Staff Report

Project Name: COA for Marquee Signage

Case Number: COA26-0002

Location: 2450 W. Main Street

Figure 3: Proposed marquee sign elevations

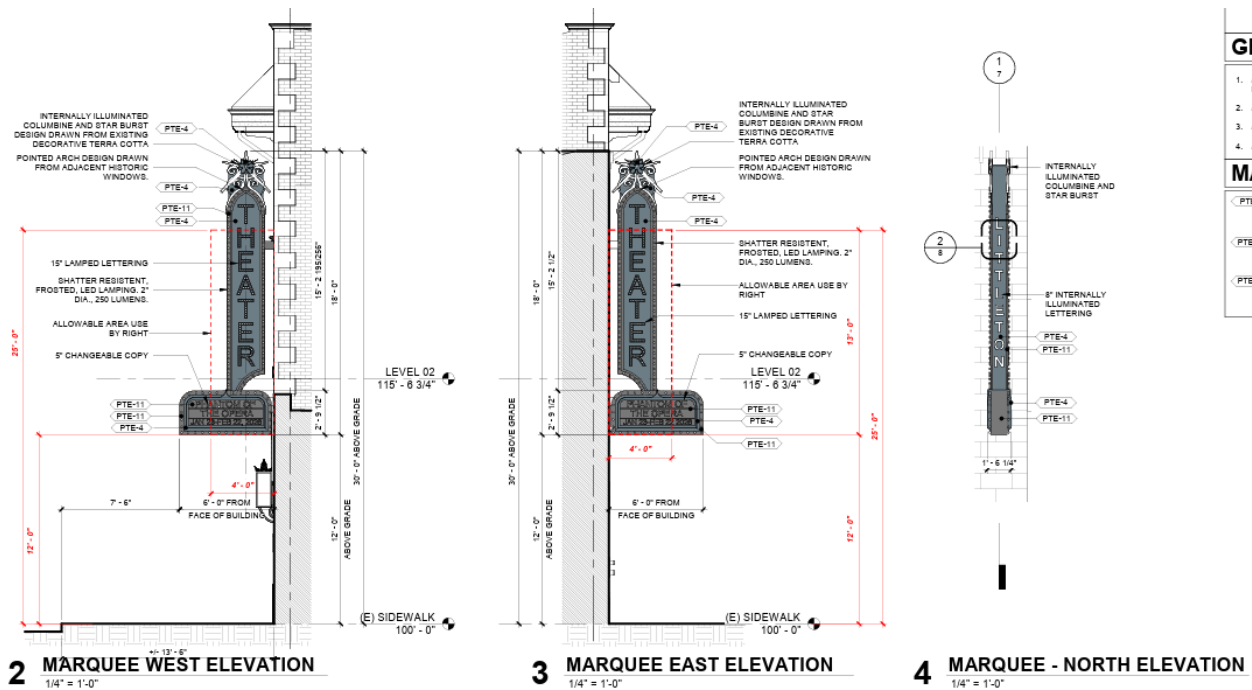
The marquee sign is composed of two main sections, a vertical section featuring decorative elements influenced by the front façade and advertising the building as a theater. The second section is horizontal in orientation and features changeable copy to be utilized for promoting shows. All components of the sign project in a perpendicular manner from the façade. The total height of the sign is 18ft with the bottom edge 12ft above the sidewalk and projecting out from the building 6ft. The vertical component of the sign is approximately 15ft-3in in height and a width of 2ft-5in. The horizontal section is 2ft-9.5in in height and 5ft-10.25in in width. The sign has a depth of 1ft-6.25in, and includes the face that is parallel to Main St. The total area of the sign is roughly 53.45sf, with the upper section at 37.13sf and the lower section at 16.32sf.

The symmetrical nature of the façade will be somewhat altered, but the sign is proportional and offset in a manner that does not affect the overall integrity or significance of the building. No other distinctive features, finishes, or construction techniques will be altered by the proposed changes. This standard appears to be met.

The proposed signage is compatible with the massing, size, scale, and architectural features of the building. The proposed signs appear contemporary but are in keeping with the scale and size of the storefronts and larger building features. The placement of the marquee on the west side of the building prevents obscuring important features or decorative elements on the façade. This standard appears to be met.

The Downtown Littleton Historic Preservation Design Guidelines defers to the Downtown Littleton Design Standards for standards related to signs in Downtown. Marquee signs are noted as allowed along Main Street and that they should be placed above entrances. The proposed sign is located on the west side of the front façade and designed with a more vertical profile. This prevents obscuring any significant features, including the original "Town Hall" signage on the

front facade. Further, *Preservation Brief 25: The Preservation of Historic Signs* notes that new signs on historic buildings should not obscure any significant features and should respect the size, scale, and design of the building. Staff finds that the placement and verticality of the sign is appropriate in relation to the historic façade and preservation guidance.

Figure 6: Section drawing depicting installation method of marquee sign

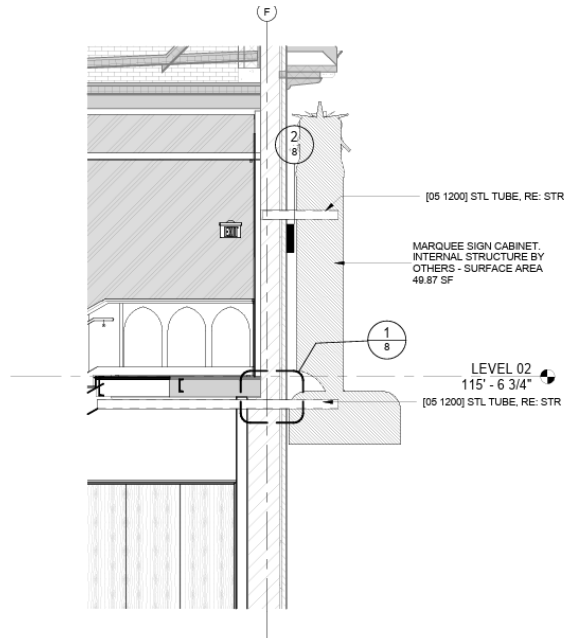
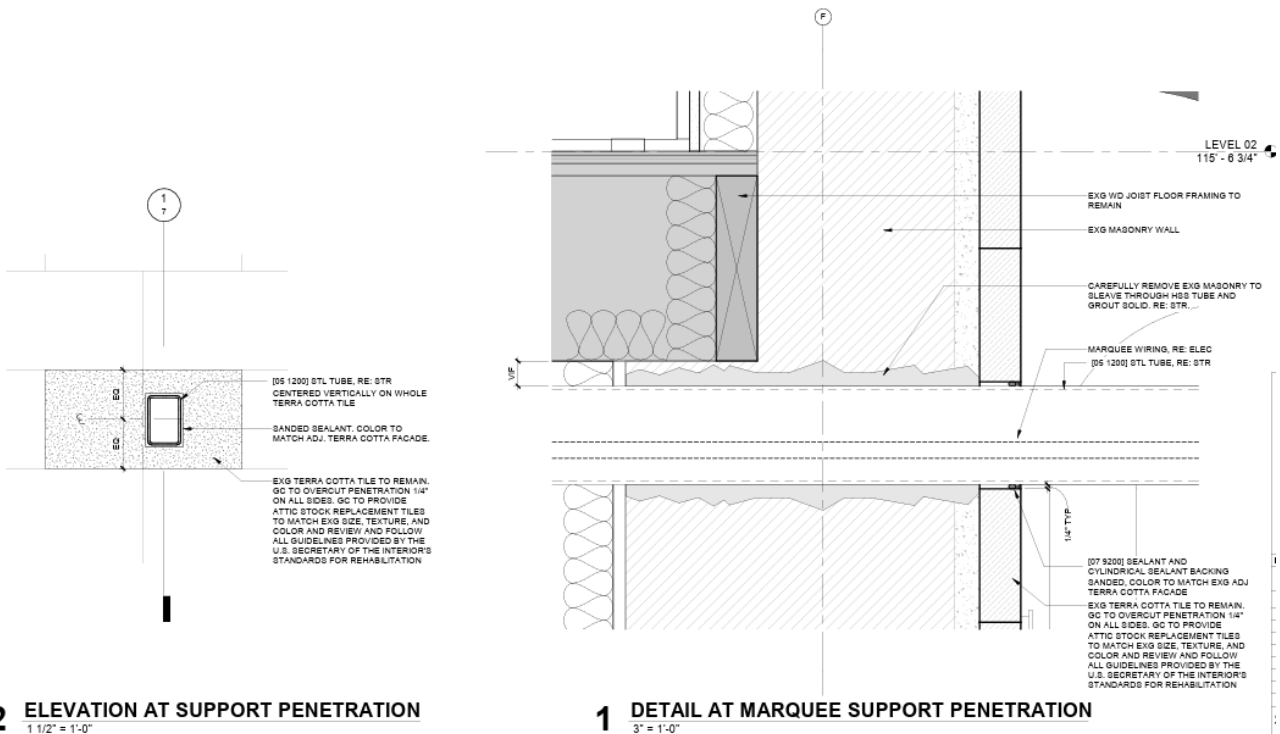
The sign will be installed via two connection points, top and bottom, with the building. Installation requires the use of a 6-in steel tube that will be inserted through a terra cotta block to mount to the internal structure of the building. Each block will be pre-cut, with an overage of 1/4in, then the tube will be inserted and sealed around the edges. If the sign were to be removed in the future, the blocks may be replaced in-kind, and it is noted on the plans attic stock will be retained for potential future use.

The overall historic character of the property will be retained. Historic materials will be minimally altered. The sign will impact two terra cotta masonry units, that will need to be replaced if the sign is removed. This standard appears to be met.

Staff finds that the proposed signs will not negatively impact the exterior features of the building. Two terra cotta masonry units will be impacted through the installation of the marquee sign, but could be replaced in-kind if the sign is removed in the future and will not reduce the historic integrity of the building. This criterion appears to be met.

- 1) The two impacted terracotta masonry units shall be replaced in-kind;
- 2) The attic stock shall be retained in the event that the marquee sign is removed in the future;
- 3) No building permit shall be issued until all required height, number, size, location, and lightning variances have been separately applied for and approved by the Appeals and Adjustment Commission.

Figure 8: Proposed sign in storefront

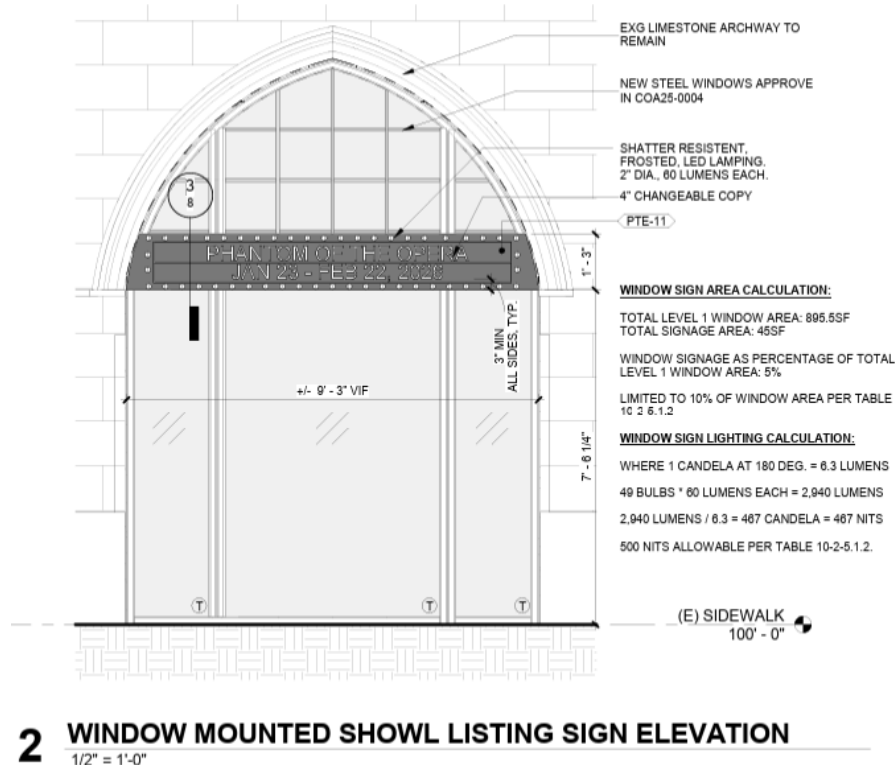
The remaining two signs will be mounted to the new storefronts that will be installed into the east and west arches of the first-floor arcade. The storefronts are not historic and were approved for installation under COA25-0005. The signs will be identical, with a height of 1ft-3in and width of 9ft-2.5in. The sign includes

changeable copy with 5in letters to advertise shows and showtimes. The sign includes exposed, shatter-resistant, frosted LED bulbs with a 2in diameter.

The proposed signage is visually compatible with the original features of the building. The window signs will be mounted to non-historic storefronts and fit within the design and scale of the storefronts. The marquee sign references existing architectural features in its design and is located so as not to obscure or negatively impact the historic façade. This criterion appears to be met.
